TECHNICAL SERVICE BULLETIN**Bulletin No.:** TSB-018**Date:** October 26, 2015**Subject:** ITT Regulator Erratic Pressure Regulation**Models:** All Quantum Fuel Storage Modules with ITT Regulators**Background**

Gen 1 BOC shown, others similar

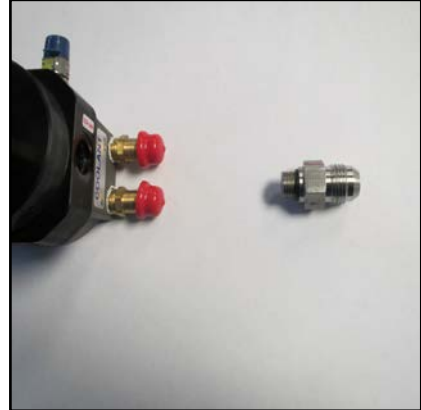
3. Slowly loosen and disconnect the fuel outlet hose from the HPR outlet fitting, use caution as residual pressure may be present in the fuel line.
